DEPARTMENT OF PLANNING AND ZONING

Re: DSP #2015-0010 – Fairfax Mews – Completeness Review

This letter serves to inform you that City staff has completed review of the Completeness Plan submitted for the above referenced project. The plans have been deemed substantially complete. The attached comments are based upon the submitted Completeness Plan, dated November 24, 2015.

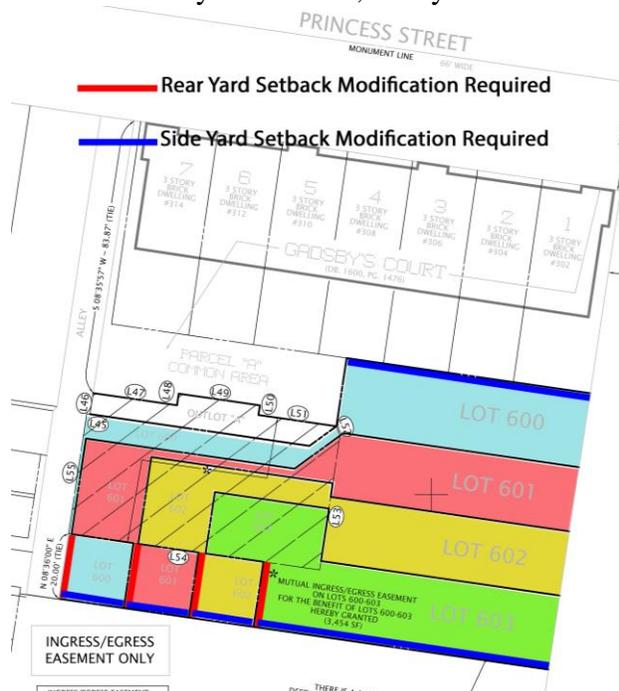
1. With the next submission, provide the following incorporating BAR direction:
 - a. Color architectural elevations
 - b. Color perspective from Fairfax Street
2. Update the plat to clearly identify all property boundaries (street and alley side boundaries)
3. An open space modification will be required for this project. Only multifamily developments in the CD zone can count roof top open space towards their required open space. Add a request for a modification to the open space requirement on the cover sheet.
4. Side and rear yard setback modifications will be required for this project. Add a request for yard setback modifications on the cover sheet for the following yards as depicted below:

Lot 600: Rear yard setback, 2 side yard setbacks
Lot 601: Rear yard setback, side yard setback
Lot 602: Rear yard setback, side yard setback
Lot 603: Rear yard setback, side yard setback
